STATE OF HAWAII
DEPARTMENT OF TRANSPORTATION
HIGHWAYS DIVISION
ROADWAY PLAN
KUHIO HIGHWAY
Retaining Walls At Lumahai And Wainiha
Project No. 560A-03-96
Scale: As Shown Date: June 15, 2011
SHEET No. 501 OF 2 SHEETS

C.O. 6

STATE OF HAWAII
DEPARTMENT OF TRANSPORTATION
HIGHWAYS DIVISION
SITE 1 - GRADING PLAN
KUHIO HIGHWAY
Retaining Walls at Lumahai and Wainiha
Project No. 560A-03-96
Scale: As Shown Date: June 15, 2011
SHEET NO. C1J OF 2 SHEETS

SITE 2 - DRAINAGE PLAN AND DETAILS
KUHIO HIGHWAY
Retaining Walls at Lumahai and Wainiha
Project No. 560A-03-96
Scale: As Shown Date: June 15, 2011

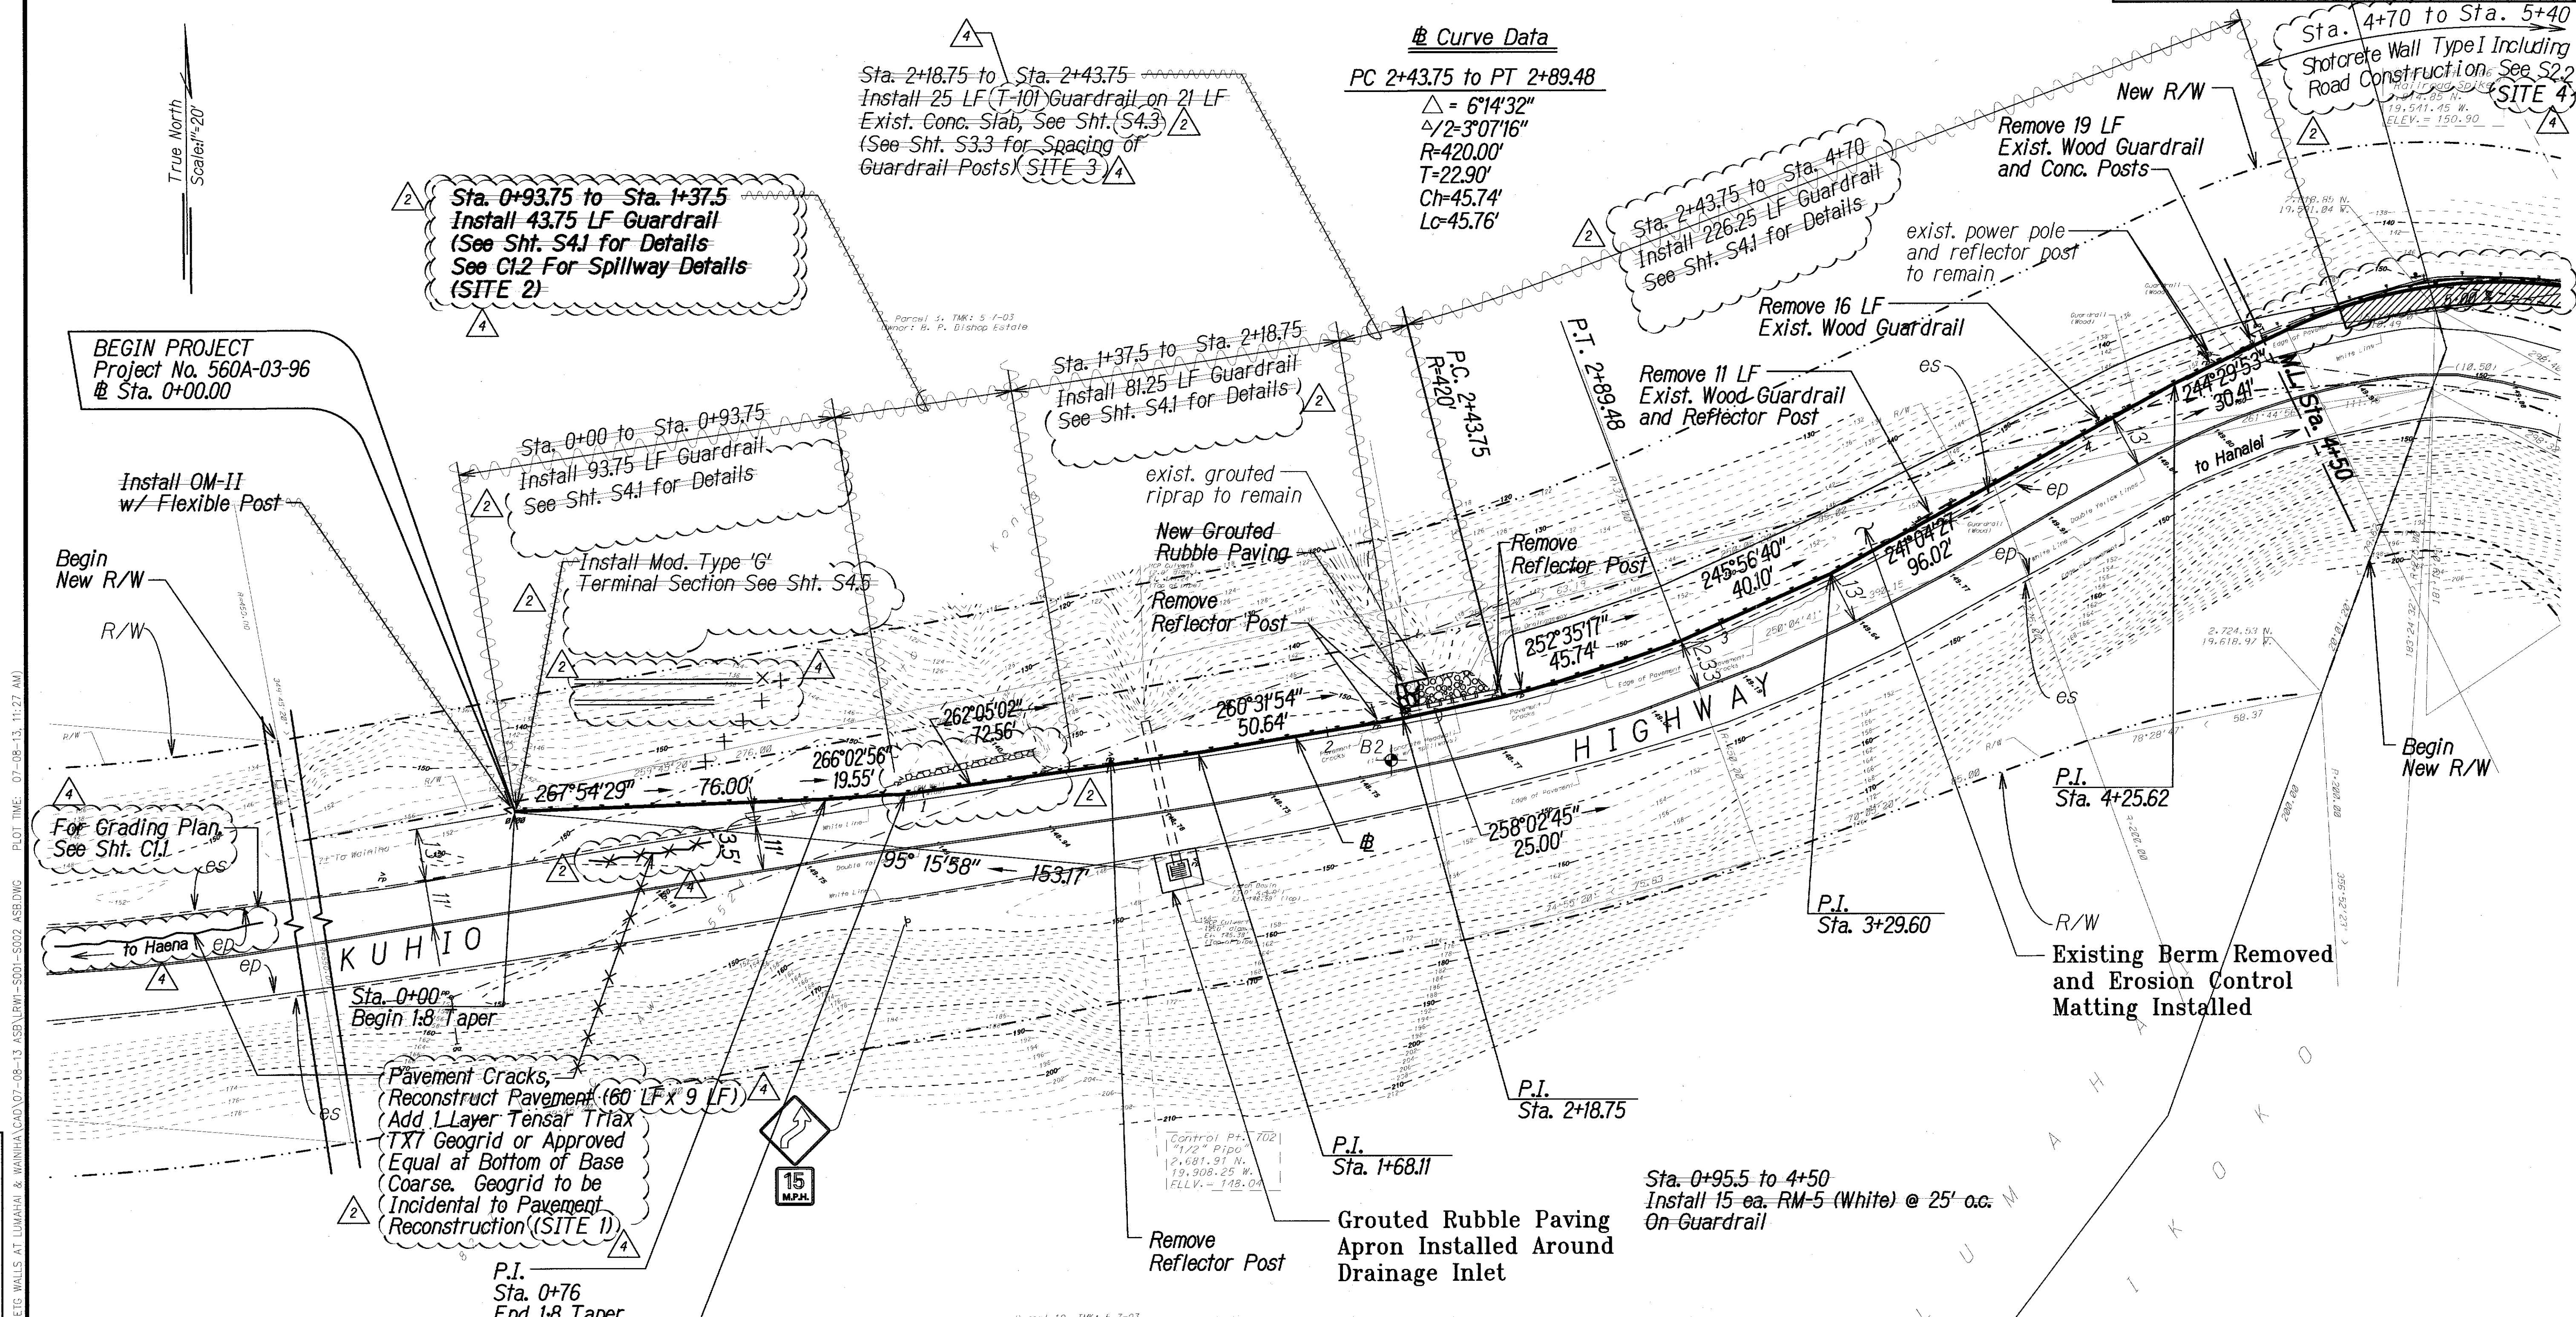
Pavement Cracks,
Reconstruct Pavement (60 LF x 9 LF)
Add 1 Layer Tensar Triax
TX7 Geogrid or Approved
Equal at Bottom of Base
Coarse. Geogrid to be
Incidental to Pavement
Reconstruction (SITE 1)

Grouted Rubble Paving
Apron Installed Around
Drainage Inlet

Existing Berm Removed
and Erosion Control
Matting Installed

DATE	REVISION
5/16/11	4 Pavement Reconstruction Locations and Clarifications
4/15/11	2 Clarification

ROADWAY PLAN

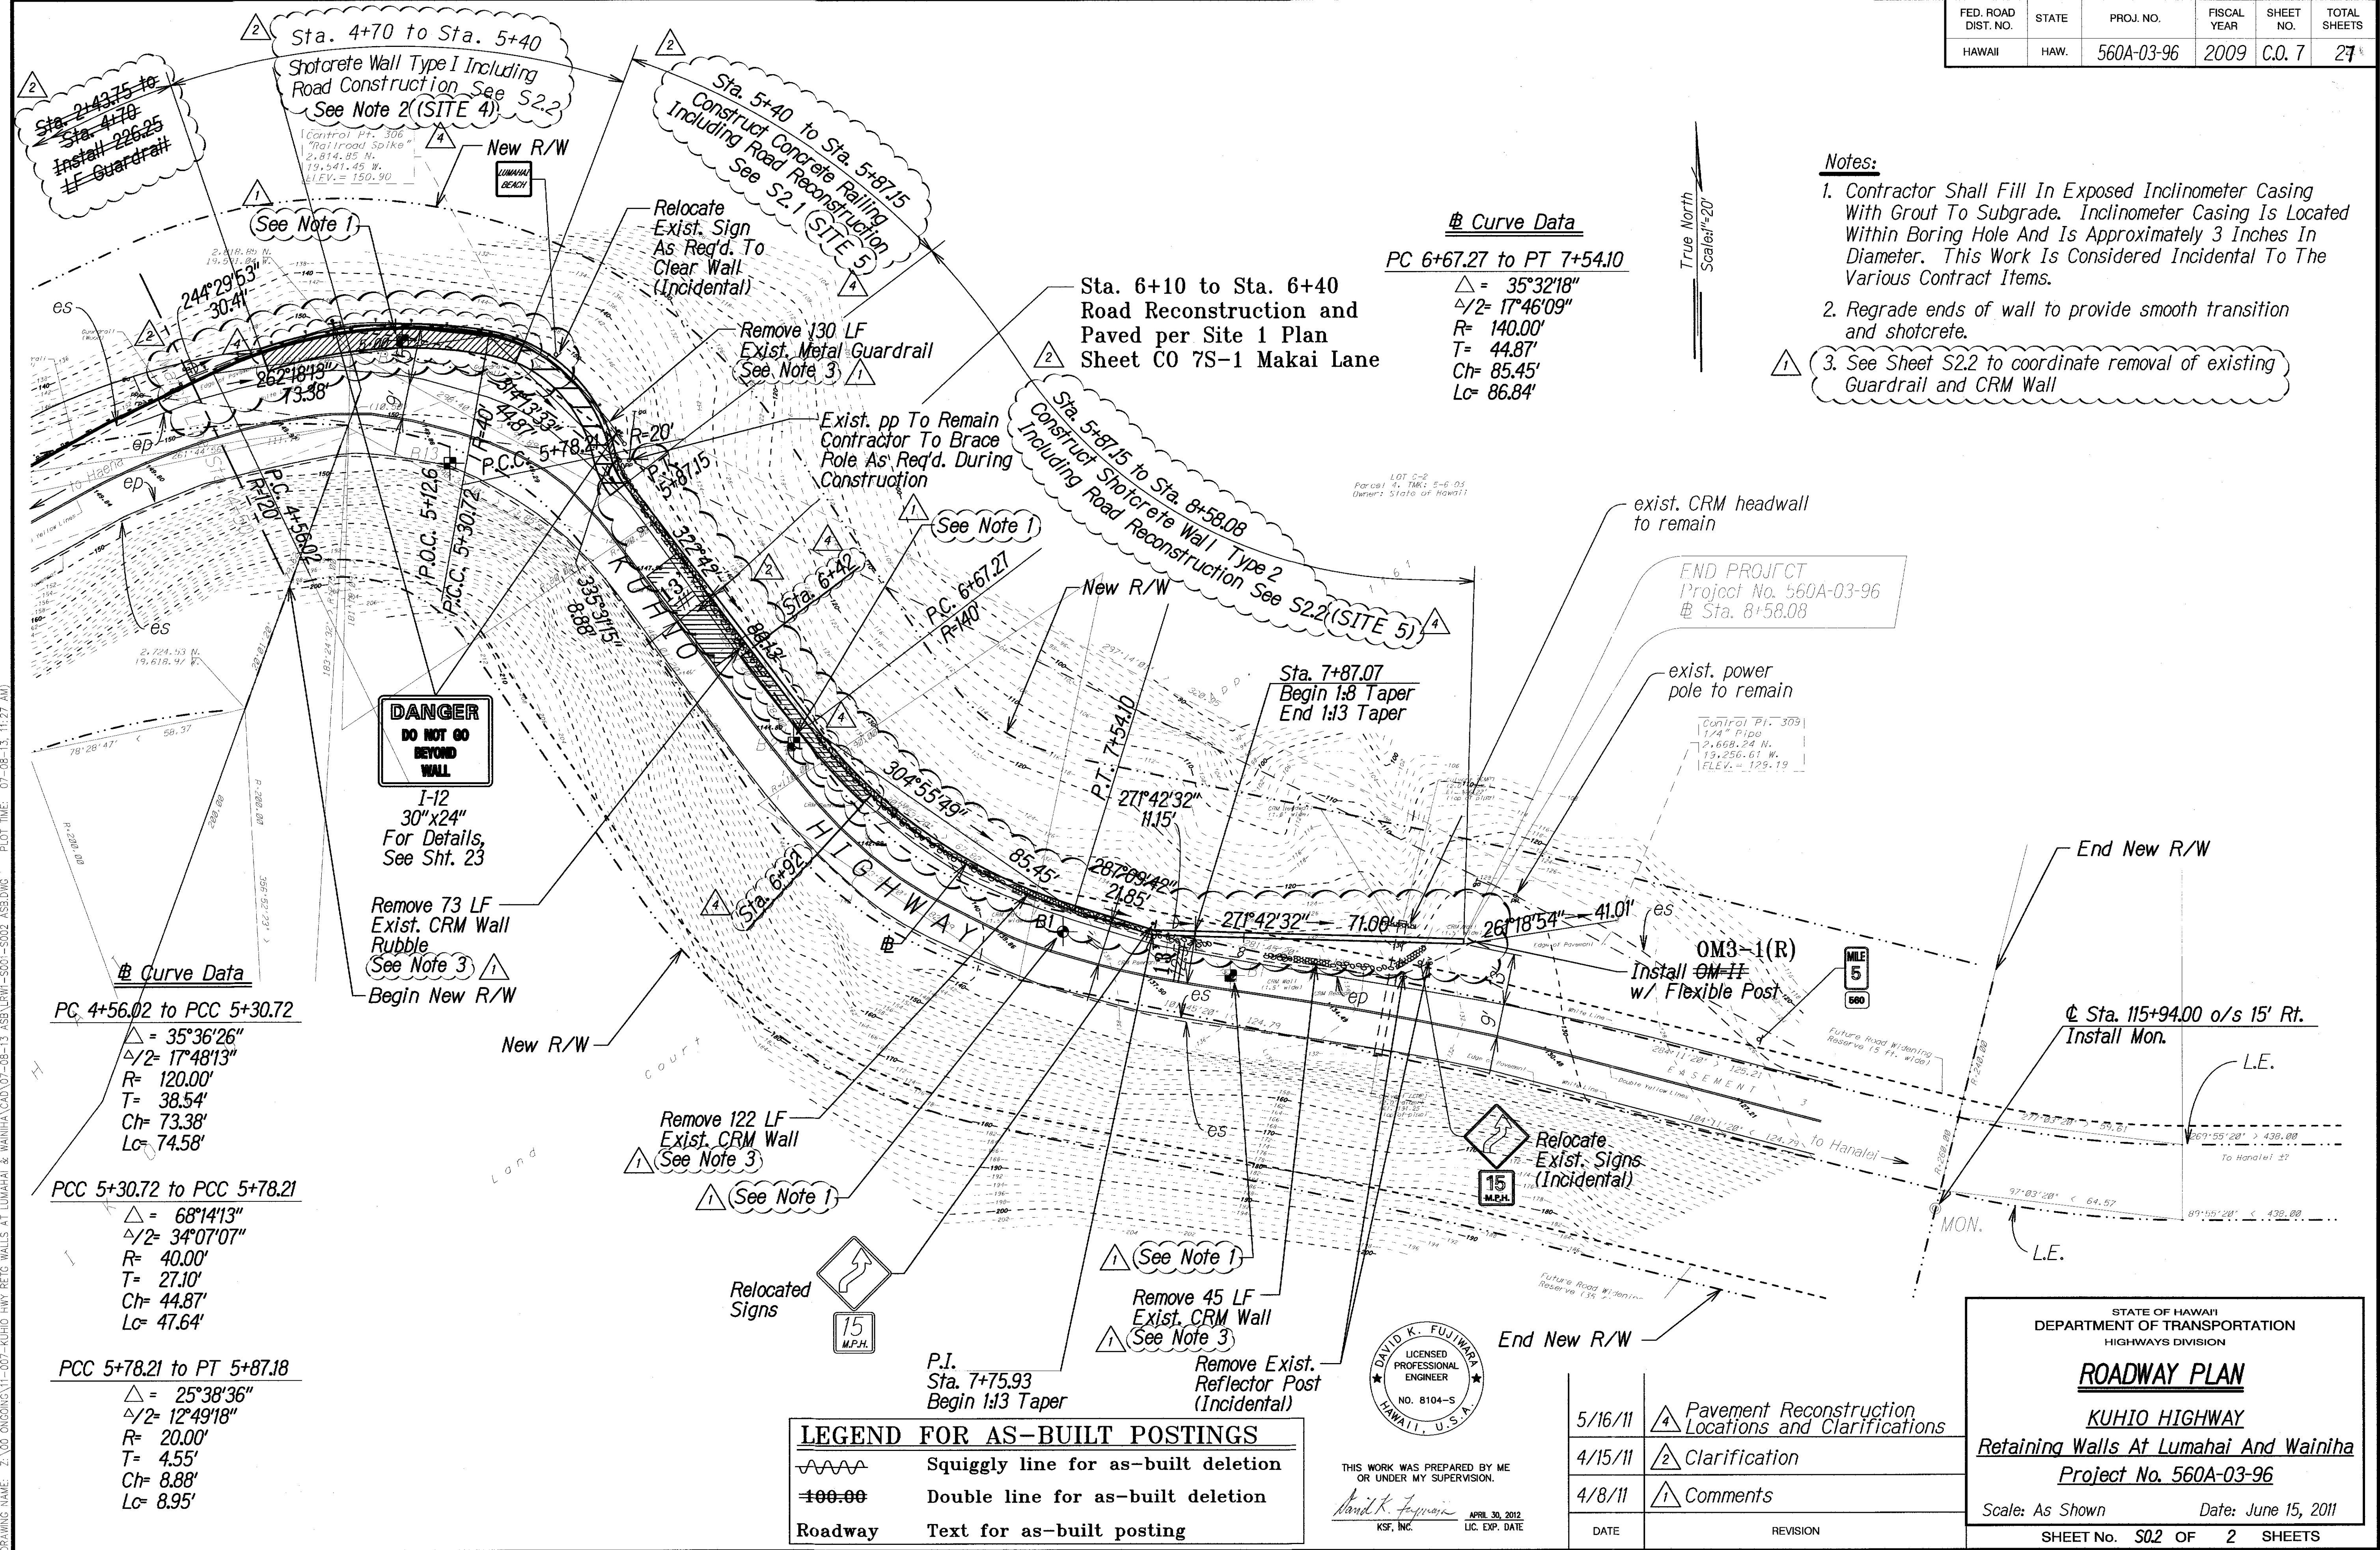
- Notes:**
- Contractor Shall Fill In Exposed Inclinator Casing With Grout To Subgrade. Inclinator Casing Is Located Within Boring Hole And Is Approximately 3 Inches In Diameter. This Work Is Considered Incidental To The Various Contract Items.
 - Regrade ends of wall to provide smooth transition and shotcrete.
 - See Sheet S2.2 to coordinate removal of existing Guardrail and CRM Wall

DATE	REVISION
5/16/11	4 Pavement Reconstruction Locations and Clarifications
4/15/11	2 Clarification
4/8/11	1 Comments
